TownePlace Suites

Village of Estero Design Review Board

January 10, 2017

Exterior Façade - Revisions

Monument Signage Approved - September 2015

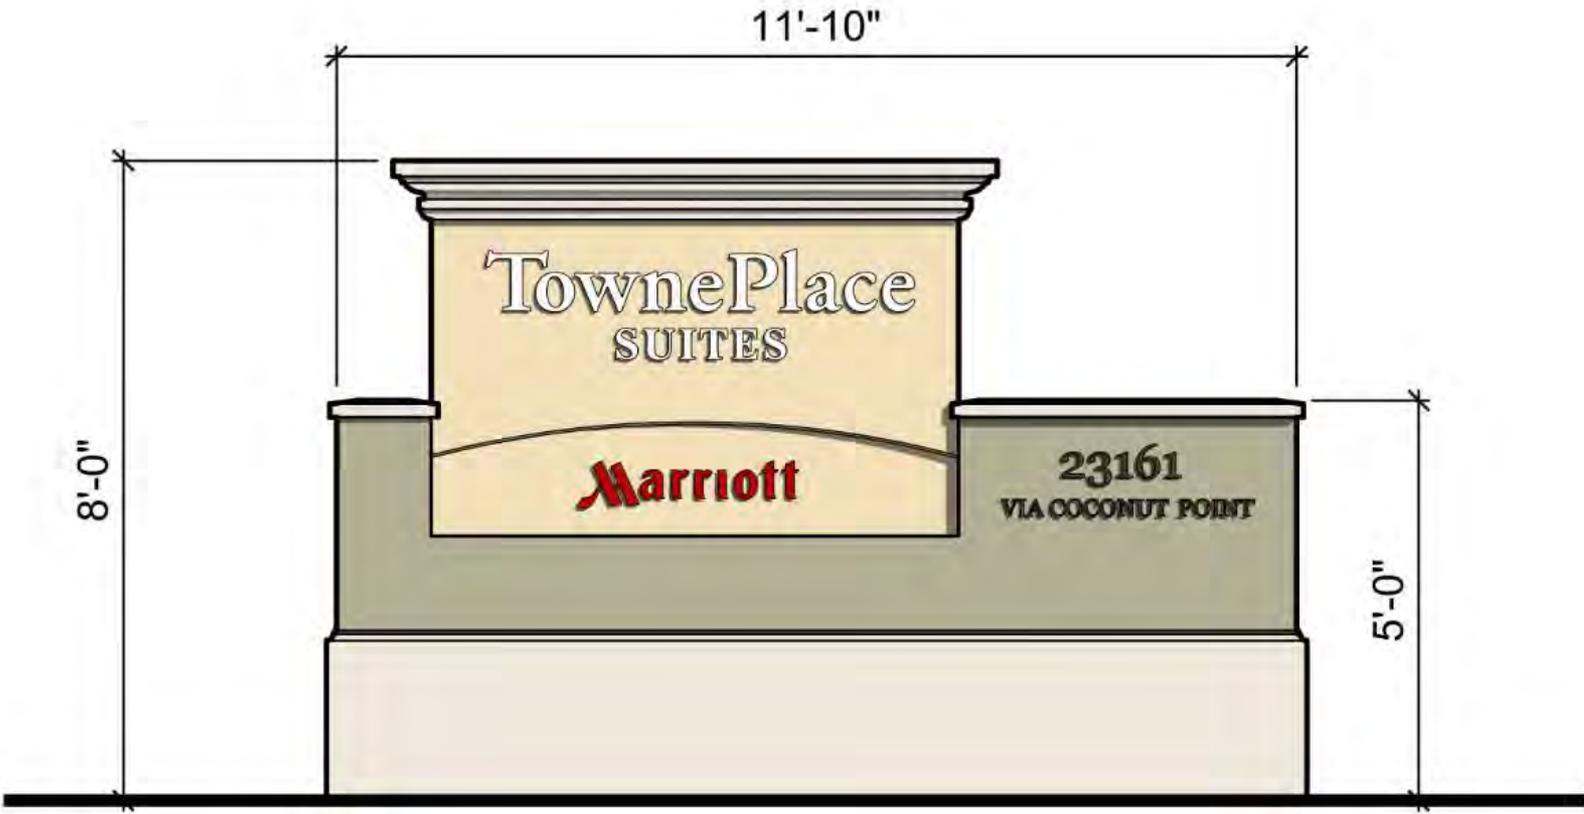
- The EDRC/Public noted that the base height is too small and EDRC was concerned about losing it with plantings.
- The EDRC/Public recommends **increasing the height to at least thirty-six inches** to better incorporate the proposed landscaping.

East Elevation January 2017 - Revised

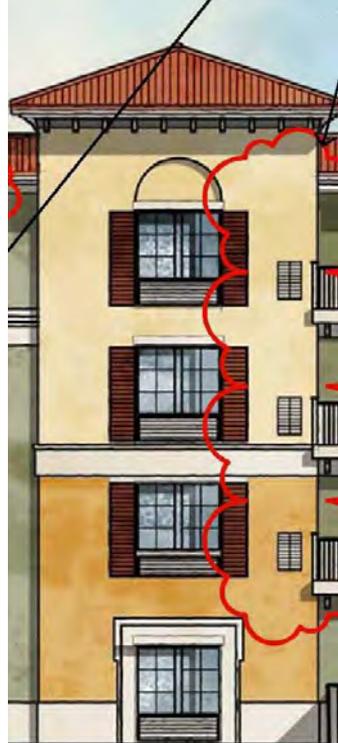
Balcony and roof overhangs eliminated per structural design requirements

East Elevation January 2017 - Revised

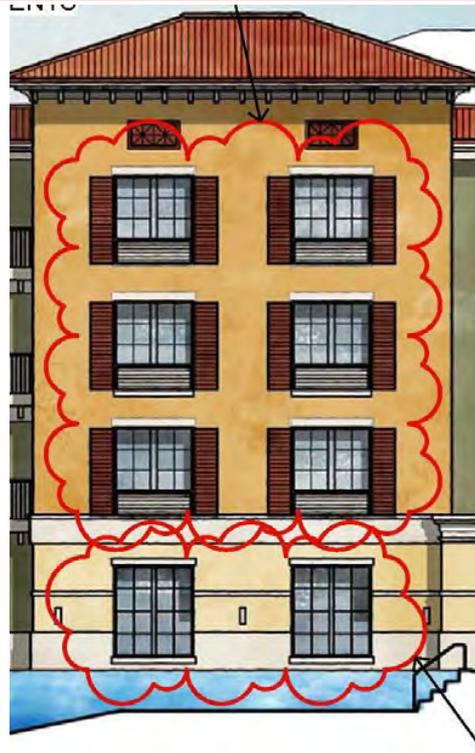
Shutters added to windows

East Elevation January 2017 - Revised

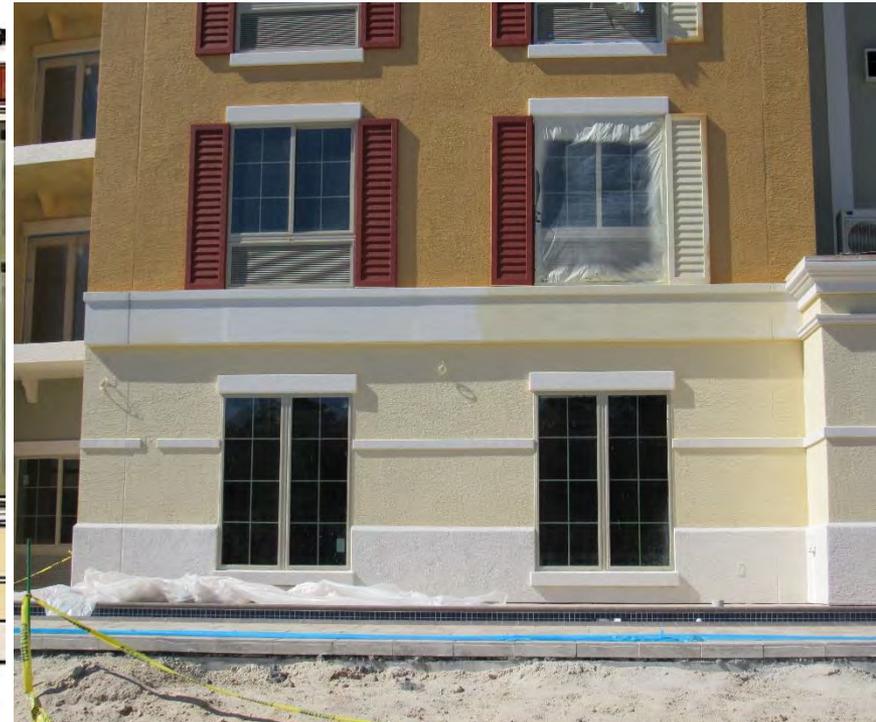
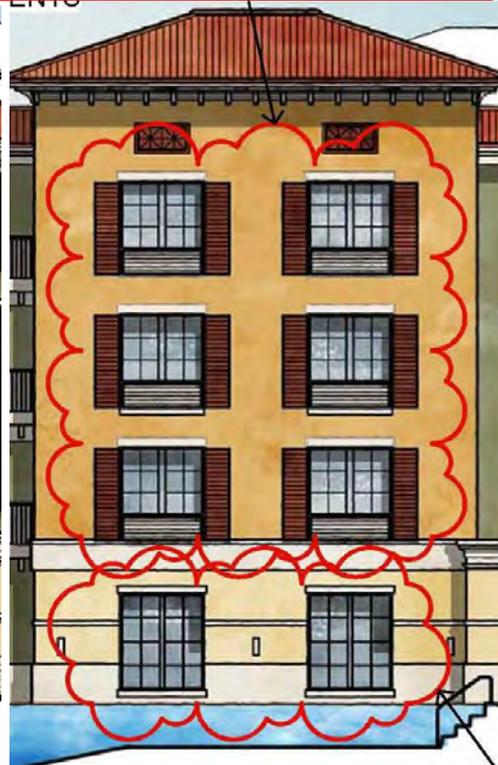
Faux shutters eliminated, windows enlarged for additional daylight in exercise room

East Elevation January 2017 - Revised

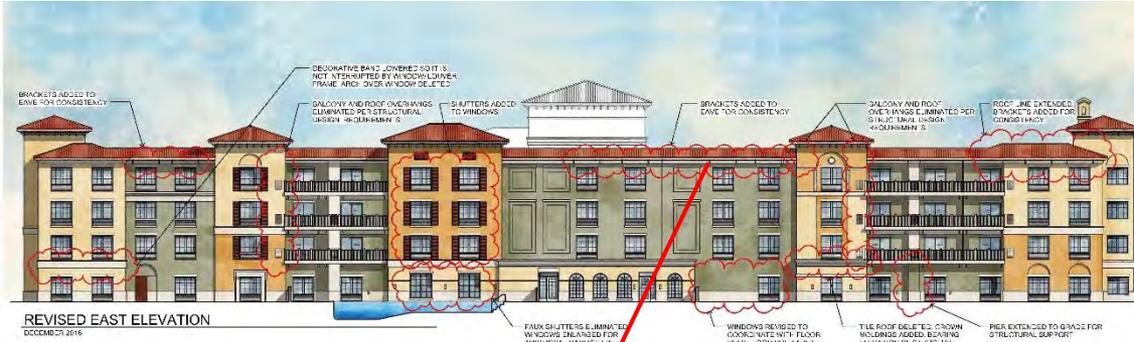
Brackets added to eave for consistency

East Elevation January 2017 - Revised

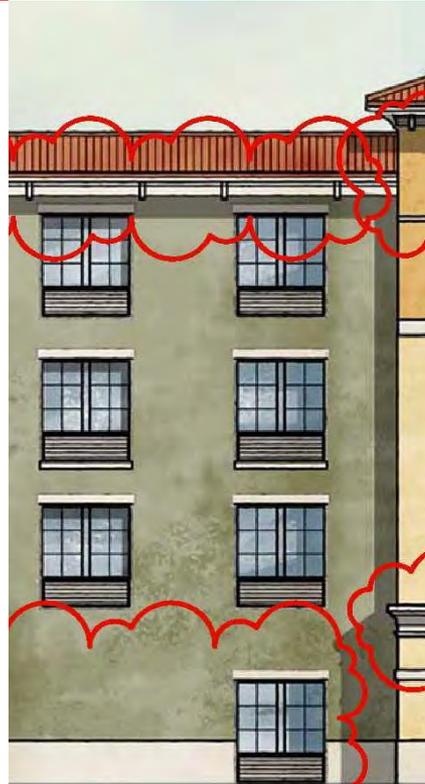
Windows revised to coordinate with floor plan – food prep area and typical guest room window configuration

East Elevation January 2017 - Revised

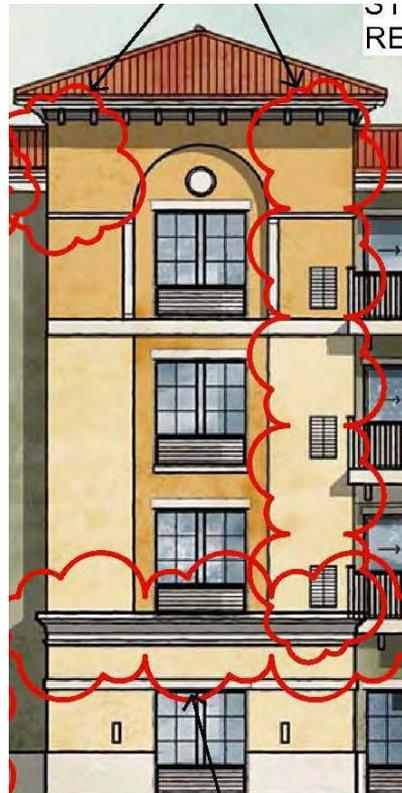
Tile roof deleted, crown moldings added, bearing elevation of structure encroached upon the HVAC unit above, prohibiting proper operation of the unit and flashing of roofing system around louver

East Elevation January 2017 - Revised

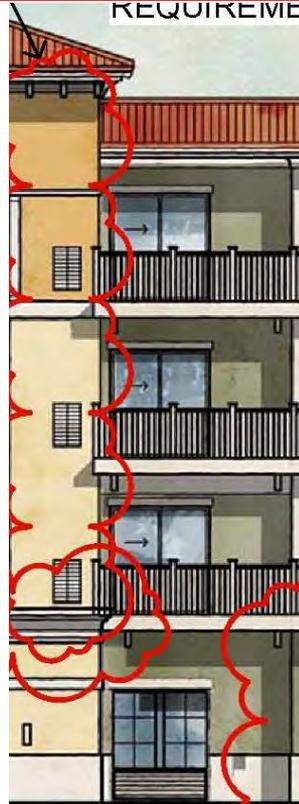
Balcony and roof overhangs eliminated per structural design requirements.

REVISED WEST ELEVATION

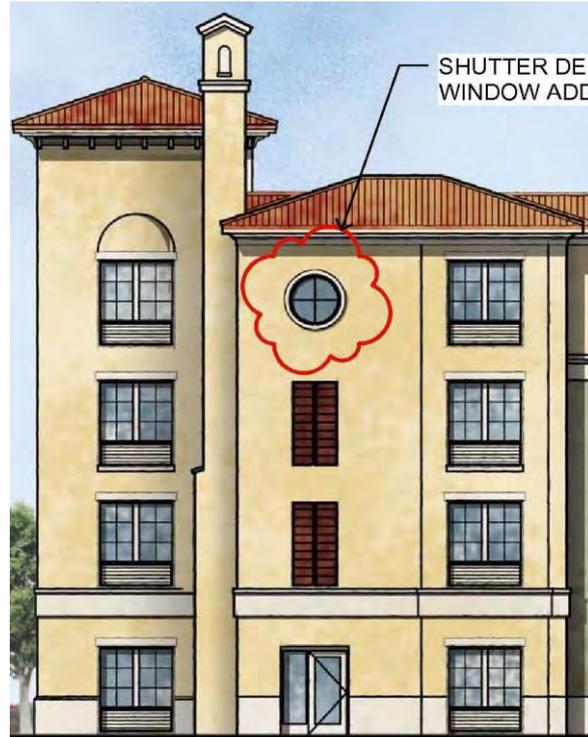
SHUTTER DELETED.
WINDOW ADDED

MEDALLION REPLACED
WITH WINDOW FOR
NATURAL LIGHT IN THE
STAIR.

ARCHTOP WINDOW
ELIMINATED TO COORDINATE
WITH INTERIOR CEILING
HEIGHT

TILE ROOF DELETED, CROWN MOLDING ADDED.
TILE ROOF ENCRROACHED ON THE HVAC
LOUVER ABOVE, PROHIBITING PROPER
FLASHING OF THE ROOF AND OPERATION OF
THE HVAC UNIT

BAND HAS BEEN LOWERED SO IT IS
NOT INTERRUPTED BY HVAC
LOUVER/WINDOW FRAME
ARCHTOP DETAIL OVER WINDOWS
BELOW DELETED.

West Elevation January 2017 - Revised

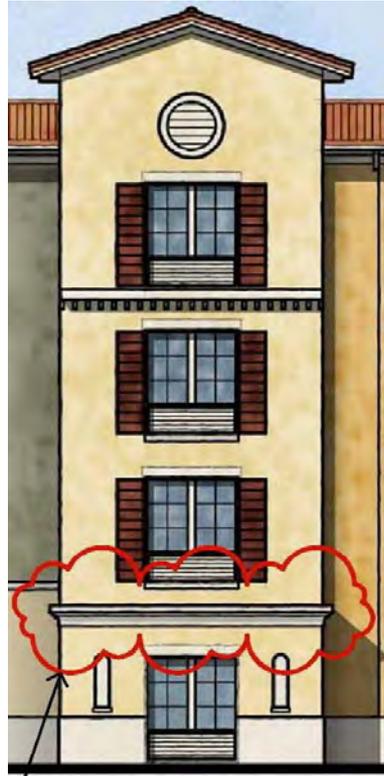
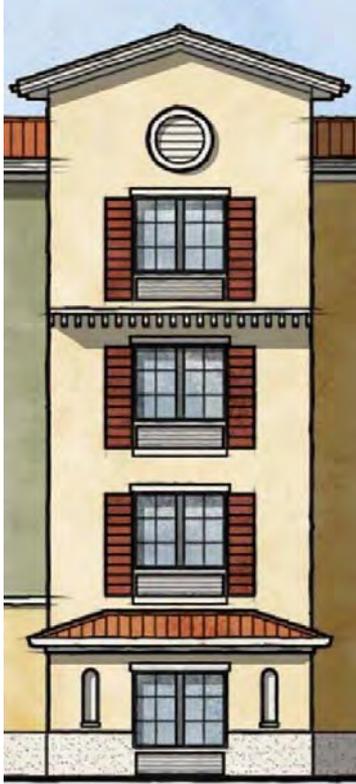
Archtrop window eliminated to coordinate with interior ceiling height

West Elevation January 2017 - Revised

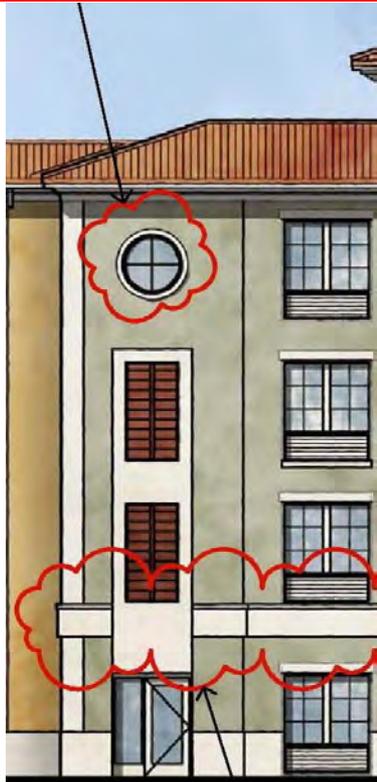
Tile roof deleted, crown molding added, tile roof encroached on the HVAC louver above, prohibiting proper flashing of the roof and operation of the HVAC unit

West Elevation January 2017 - Revised

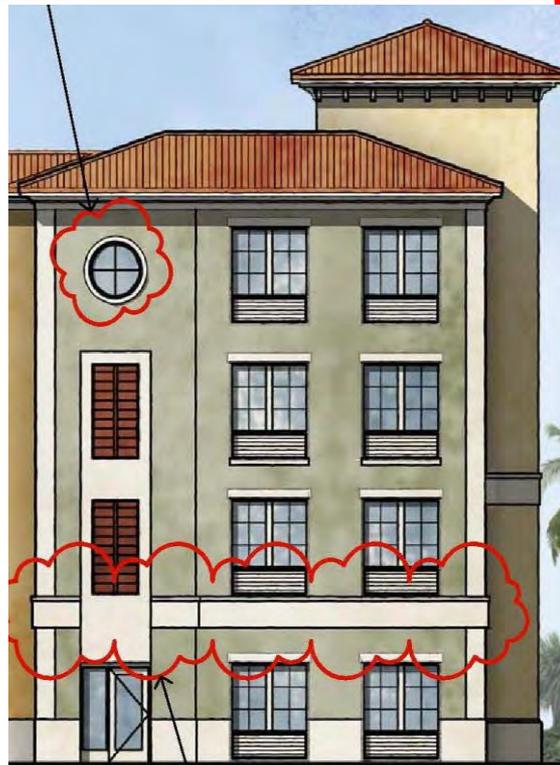
Band has been lowered so it is not interrupted by HVAC louver/window frame. Archtop detail over windows below deleted.
